MOTORCYCLE PARTS NEWS

NUMBER 397

TX750 — CRANKSHAFT, Design Change

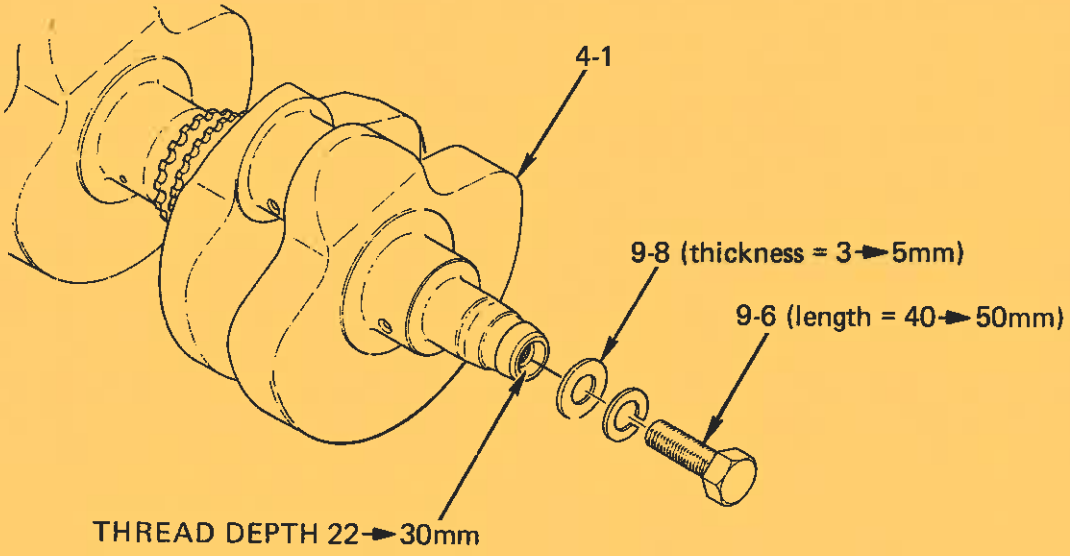
The AC generator rotor securing bolt and washer have been changed for greater strength. A corresponding change has been made to the crankshaft. See details of change in illustration below. Correct your Parts List per the Parts Ordering information.

INTERCHANGEABILITY: Okay as set.

SALE OF PARTS: Crankshaft — When old type out of stock, only new will be sold.
Bolt/Washer — Both old and new type will continue to be sold.
